Walnut Creek Water Treatment Plant Pretreatment Project Final Environmental Impact Report

Volume IV – Final EIR

Final Environmental Impact Report
Volume IV – Final EIR

Figure 8-1: Site Plan of Staging Area 4

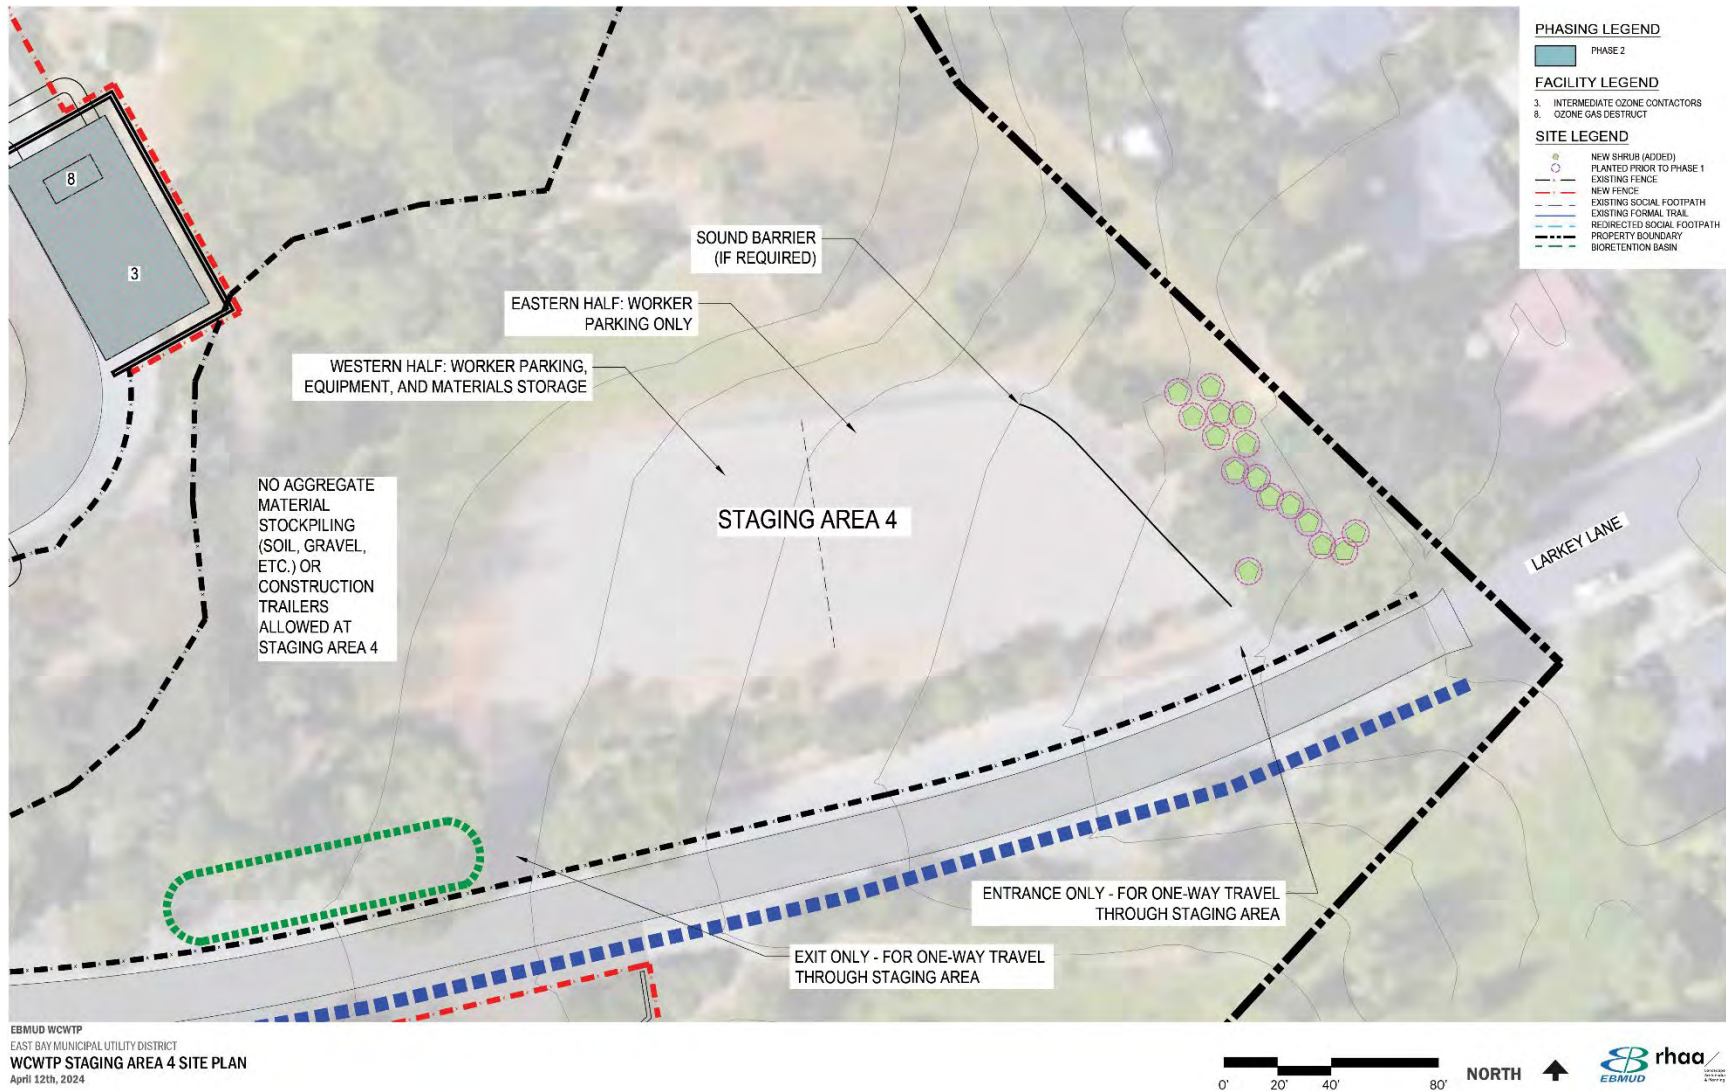
Some comments on the Draft Environmental Impact Report (EIR) raised concerns or questions regarding use of the existing parking area located near the entrance to the Walnut Creek Water Treatment Plant (WTP) close to the intersection of Larkey Lane and Alfred Avenue for construction staging. Comments expressed concerns regarding visibility of facilities constructed as part of the Walnut Creek WTP Pretreatment Project (Project) from the Briones to Mt. Diablo Regional Trail. Comments also raised questions about the need for the Project and size of the Project, use of Larkey Lane as an access route, chemical handling and storage safety measures, communication during construction, and the community evacuation process. These comments are most appropriately addressed in seven comprehensive, or “global,” responses.

As explained in the Draft EIR, on page 2-30 of the Project Description, “Staging Area 4 would be used for material and equipment storage on the western half and for worker parking on the eastern half – no aggregate material stockpiling (soil, gravel etc.) or construction trailers would be allowed” and this is depicted in **Figure 8-1** below, which shows a zoomed in view of Staging Area 4. Limiting the activities at Staging Area 4 would reduce the potential for noise-generating activities at Staging Area 4 because no aggregate materials handling would take place there. Staging Area 4 would not be lighted, and no new security fencing would be installed.

To further clarify material and equipment storage activities that would take place at Staging Area 4, the Draft EIR, page 2-30, at the end of Section 2.6.1, Staging and Stockpile Areas, has been revised as follows:

Also, as noted in Section 2.8.2, Permanent Staging Area Use, on page 2-37 of the Draft EIR, after construction is completed, Staging Area 4 would revert back to emergency parking and would not be used under normal operations.

Figure 2-3: Revised Walnut Creek WTP Site Plan and Phasing

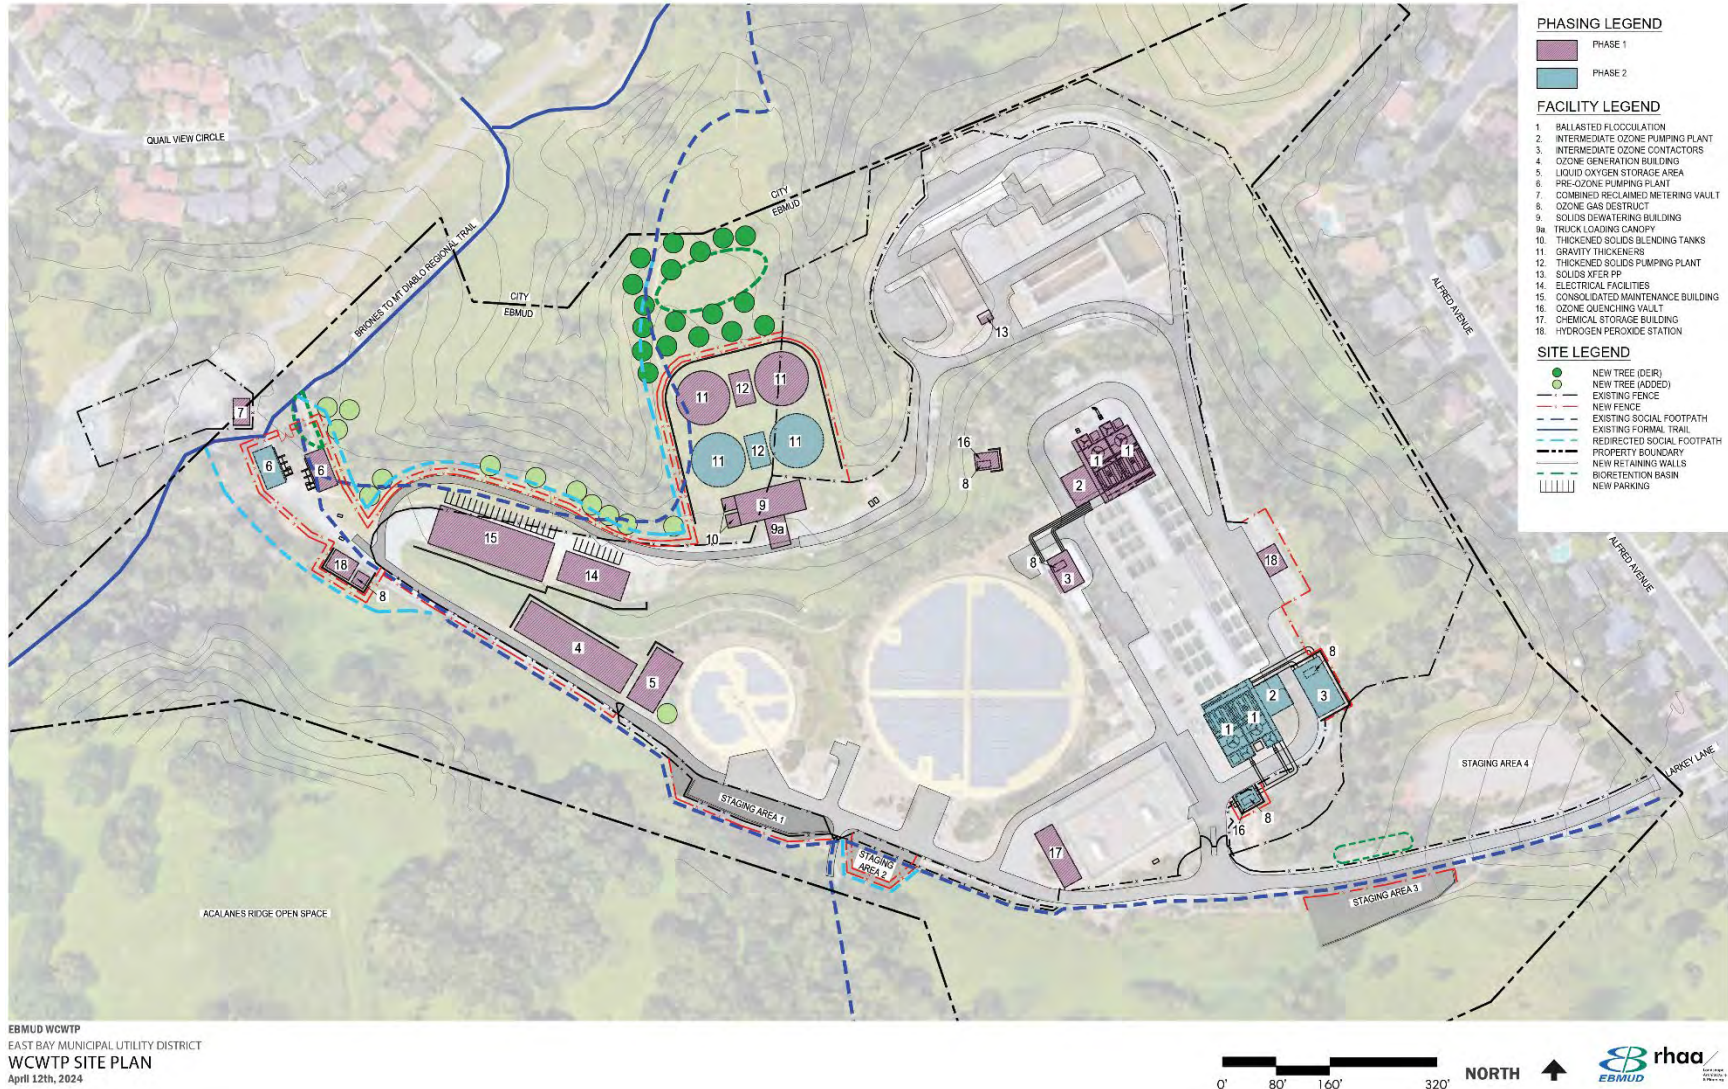
Some of the comments suggested additional plantings and requested that trees be planted before the start of construction to provide increased height and density of trees sooner. One of the comments specifically requested additional tree plantings outside of the retaining wall on the western side of the gravity thickeners, and in front of the consolidated maintenance building and electrical building. EBMUD evaluated these comments and determined it is feasible to add additional trees along the northern side of the Walnut Creek WTP in front of the consolidated maintenance building and electrical building by adjusting the location of the consolidated maintenance building and a portion of the paved north access road. The updates to the site plan, including the additional tree locations are shown below in revised **Figure 2-3** below.

Most of the facilities at the Walnut Creek WTP would be screened by topography and existing vegetation and structures, so extensive plantings to screen structures would not be required. As shown in **Figure 2-3**, approximately eighteen 24-inch box trees would be planted north and northwest of the proposed gravity thickeners and approximately twelve 24-inch box trees would be planted east of the pre-ozone pumping plants and north of the consolidated maintenance building and electrical building to screen new facilities ~~them~~ from view from the Briones to Mt. Diablo Regional Trail and the neighborhood to the north of the site. One tree would be planted southeast of the liquid oxygen storage facility to screen the storage area from view from the social footpath south of the Walnut Creek WTP southern boundary. During detailed design, the orientation, layout and sizing of the gravity thickeners, thickened solids pumping plants, and solids dewatering building and surrounding retaining will be optimized for efficient use of space, and additional trees would be sited and planted to the extent feasible on the west side of the retaining wall to further enhance screening of the new facilities. New trees would be ~~a combination of~~ coast live oak (*Quercus agrifolia*) ~~and valley oak (*Quercus lobata*), both of which are~~ currently present at the site. ~~Both~~ Coast live oak species are drought tolerant California natives. Additionally, coast live oak is evergreen and would provide year-round screening. EBMUD’s standard hydroseed mix of native grasses is proposed under the new tree plantings. The proposed landscaping would require minimal irrigation and maintenance, although temporary irrigation (up to about five years) would be required to establish trees. Tree locations shown in **Figure 2-3** are planning level, and tree locations may be adjusted to provide the most optimal screening of new facilities, accounting also for topography and to ensure tree survivorship. All trees planted for landscaping will be irrigated, monitored maintained, and replaced, as required, by EBMUD post-construction to guarantee the future health and survivorship of all landscaping trees.

Figure 2-3 on page 2-4 of the Draft EIR is revised as shown above to show additional trees that would be planted. Trees that have been added since publication of the Draft EIR are shown in light green. The revised figure is also included in Section 10.2 of Chapter 10, Draft EIR Revisions.

Exhibit 3-Proposed Trees and Trail Improvements

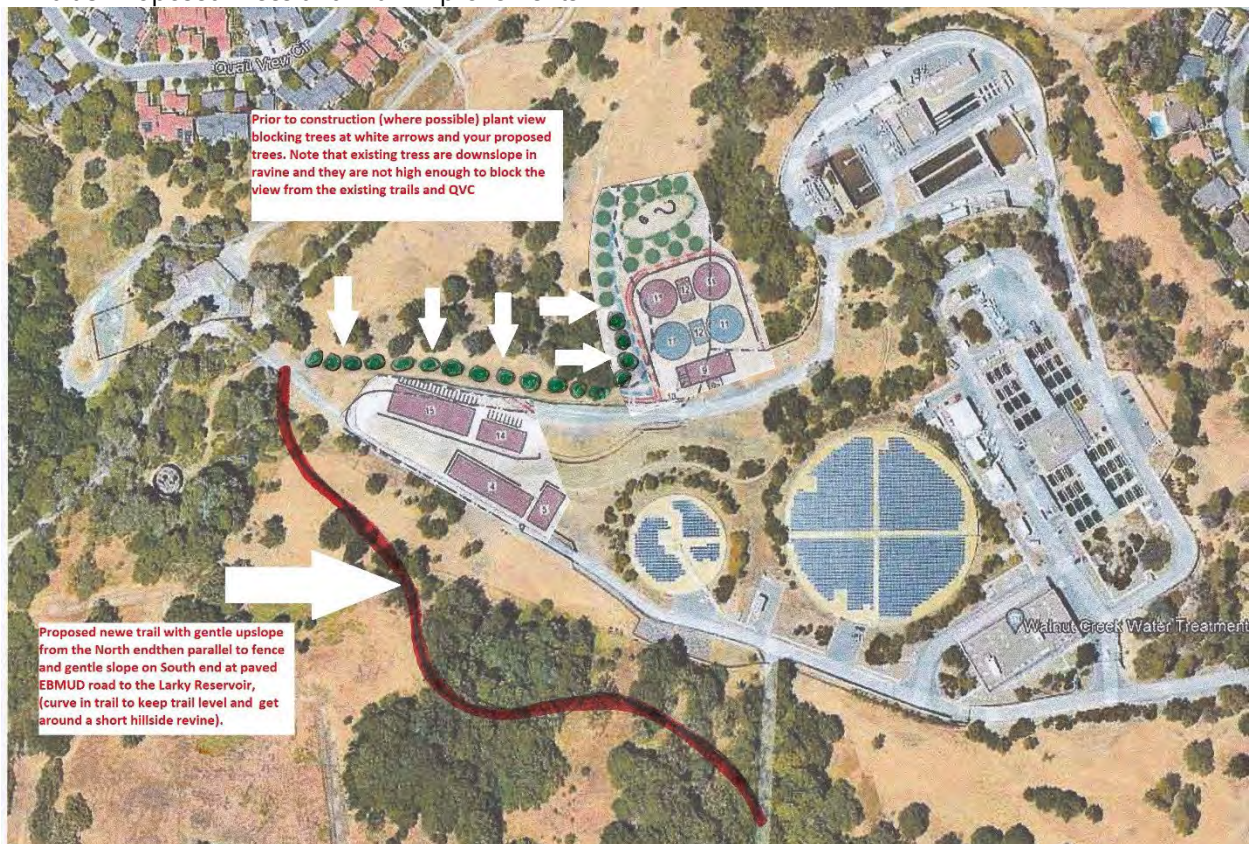
I am including with this email, a drawing (Exhibit -3-) that I have modified after walking the site with Stephen Clark (another QR homeowner), and taking pictures at various locations and offering these comments related to, and the photos of, our having walked the property a few days ago.

From the photos, Exhibit 4, 5, 6, 7, you can see that there are many gaps allowing views of EBMUD's proposed buildings and tanks to be built on the property from the many points on the trails and from Quail View Circle homeowners. These must be filled in with additional trees, NOTE! the trees that you see on the Google Earth image are down in the ravine, and the tops of those trees do not provide any visual blockage of the construction areas and the new facilities see Exhibit 8, 9. the view looking from the trail to your new construction area Exhibit(s) 10, 11, 12, 13, 14, show various views from opposing directions.

Figure 3.11-5: Sound Barrier Locations

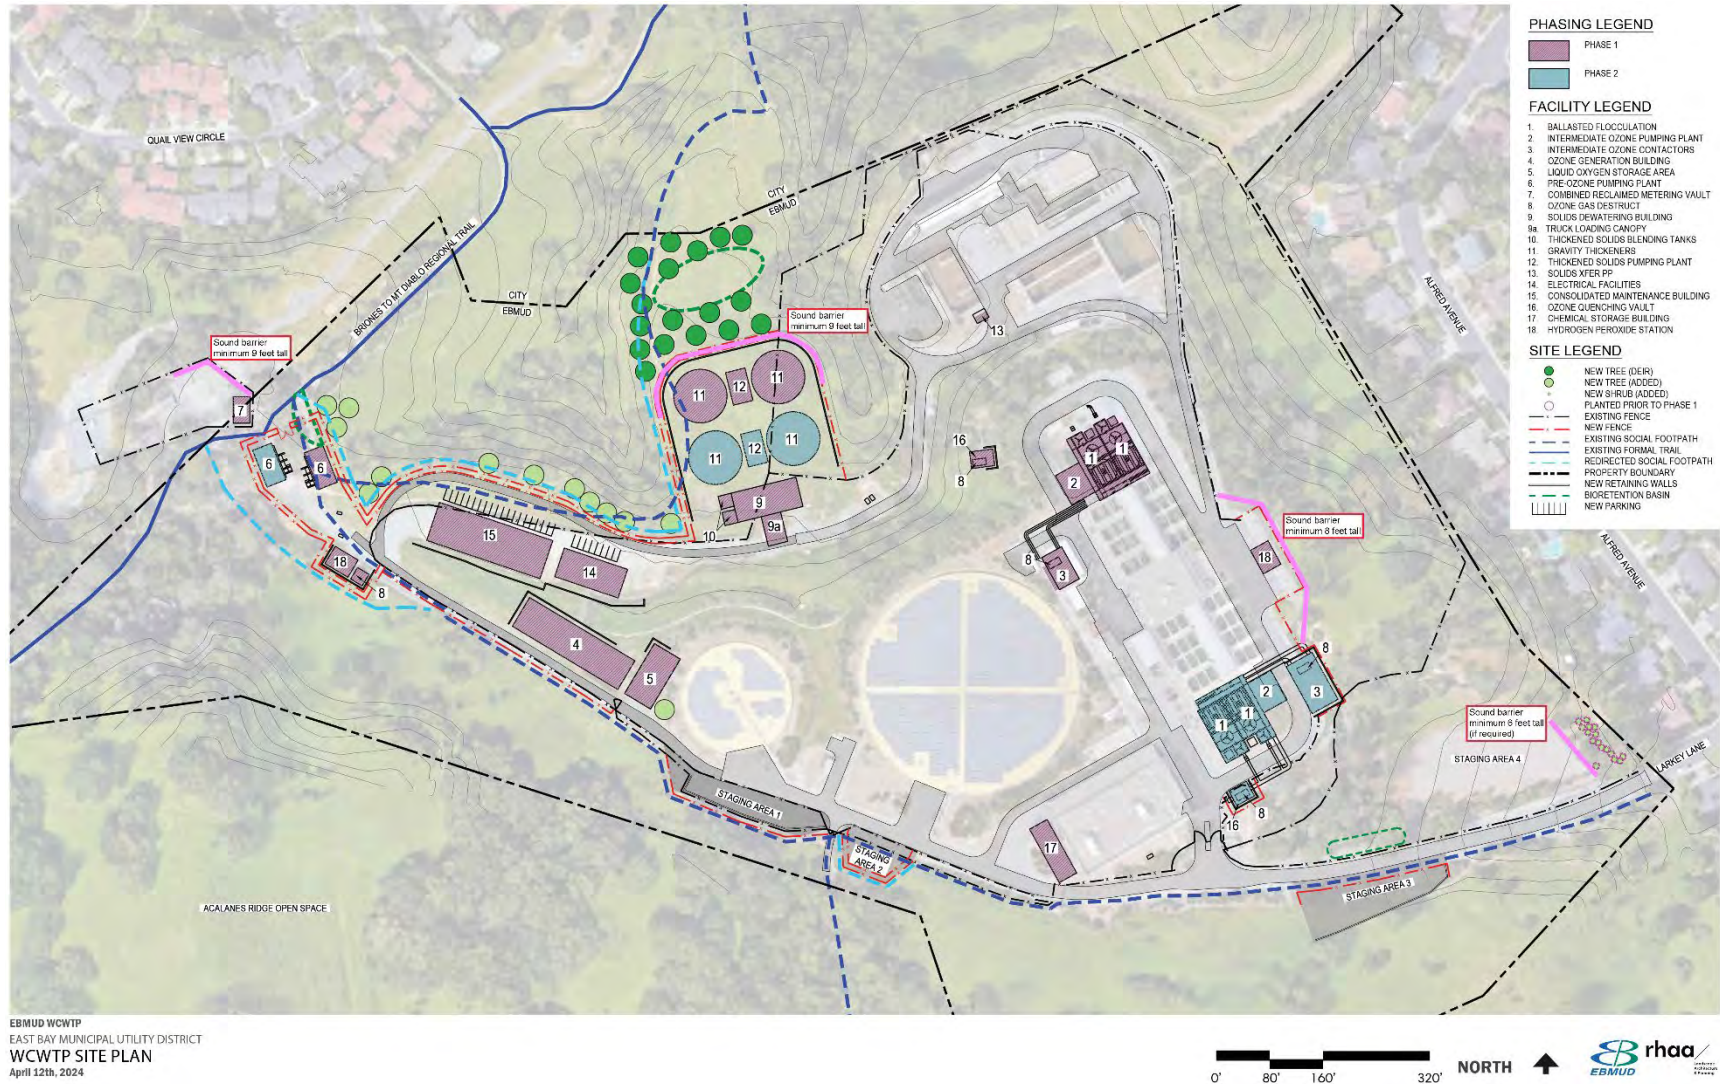
On page 3.11-42 of the Draft EIR, Mitigation Measure NOI-1 lists the heights of the proposed sound barriers. However, for Staging Area 4, Mitigation Measure NOI-1 has been revised to require a redwood fence only if noise monitoring finds noise thresholds are exceeded. If required, the redwood fence at Staging Area 4 would be 6 feet tall and located at the far eastern end of Staging Area 4 (as shown in Figure 3.11-5 on page 3.11-35 of the Draft EIR).

Page 3.11-35, Figure 3.11-5, Sound Barrier Locations has been revised to indicate that the sound barrier would only be installed at Staging Area 4 if required based on noise monitoring during construction, and to show the 16 5-gallon shrubs that will be planted in the area east of Staging Area 4 prior to construction to provide visual screening in the anticipation that a redwood fence would be needed.

Page 3.11-42, Mitigation Measure NOI-1 has been revised as follows to refine the approach for mitigating potential noise impacts associated with the use of Staging Area 4:
